# Access Compliance Report

## Public Rights-of-Way

### (Curb Ramps)

Intersection ID: 14071	Main Street: CLEVELAND_AV	Cross Street: E_KINGSTON_AV	Location: E
ADA ID: C0157D764AC0	Ramp Type: Directional1	Initial Pass/Fail: Fail	Overall Compliance: No
		Severity Score: 1.25

#### Codes/Mitigation Info/Possible Solution

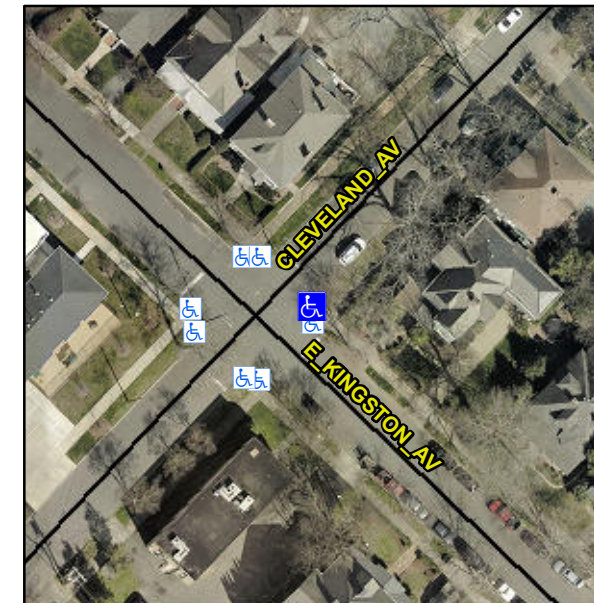
Surveyor Notes:

**NO CURB LINE**

PROW/ADA:

**R304.5.3**

Possible Solutions:

**Remove & Replace Entire Ramp.**
